ATTACHMENT A

KENWOOD COMMUNITY & SENIOR CENTER ATTACHEMENT A

ADDENDUM #1 – REVISED DRAWINGS

3/4" = 1'-0" **12**

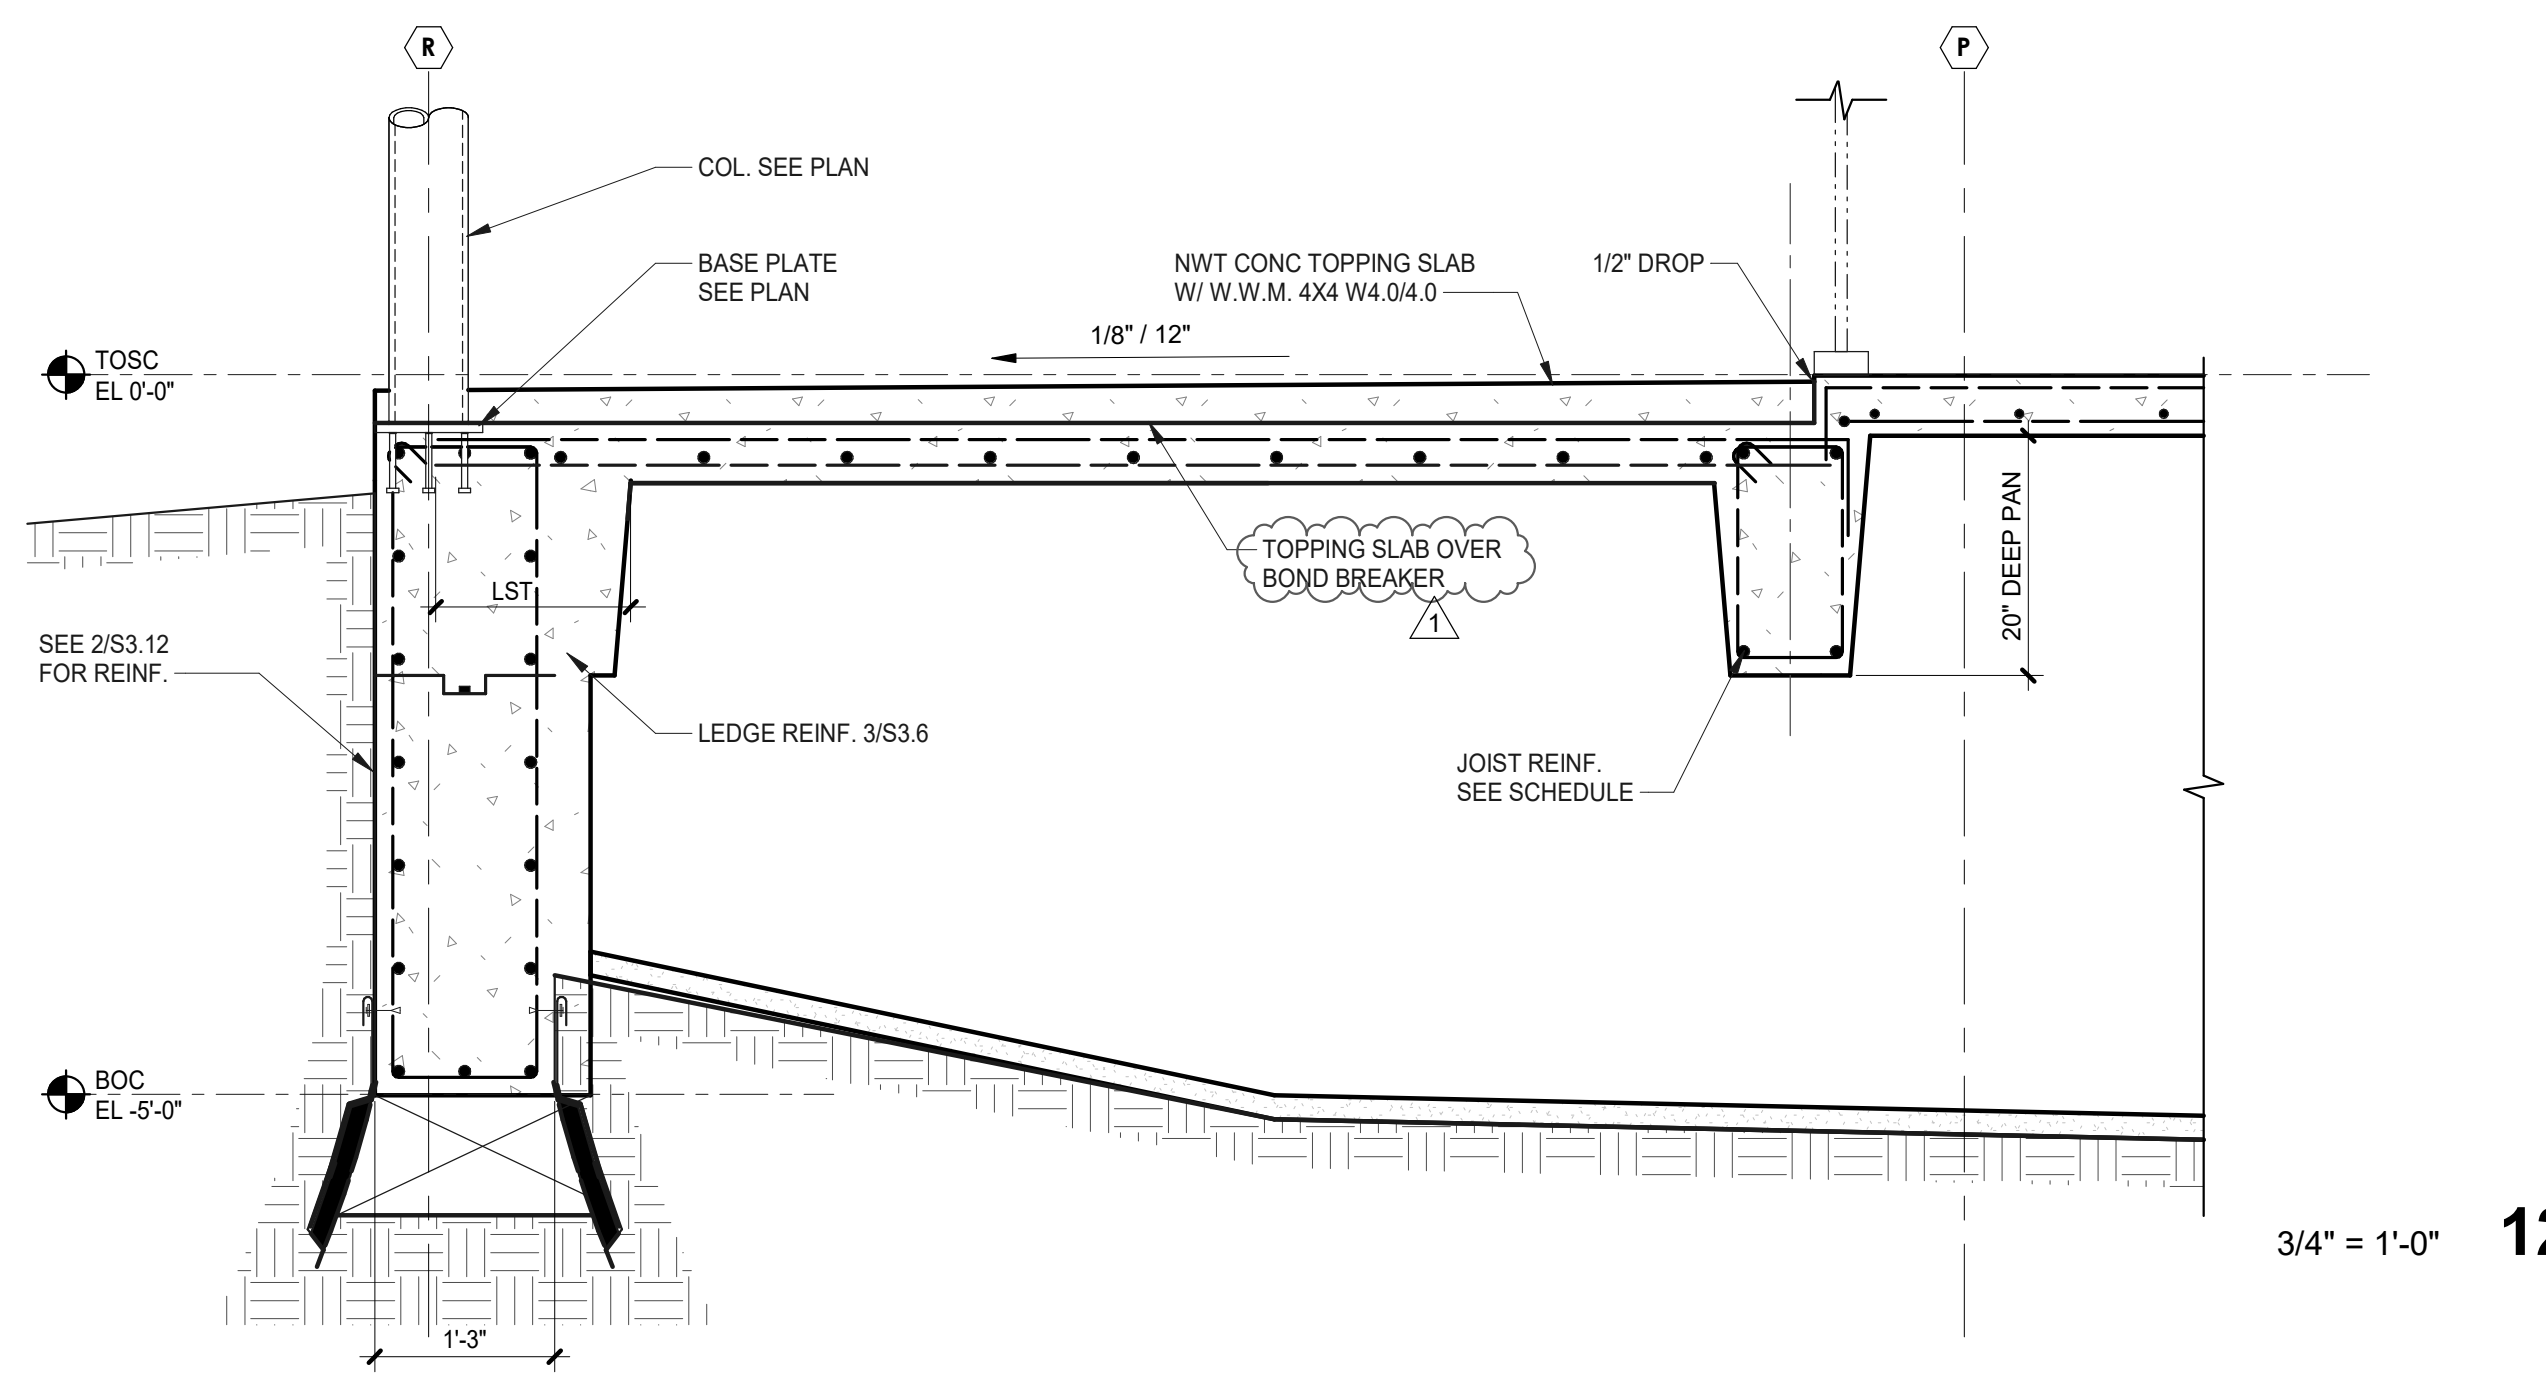
A requirement has been added to ensure the pan removal hatch is not located within polished concrete areas, refer to attached revised sheet S3.8.
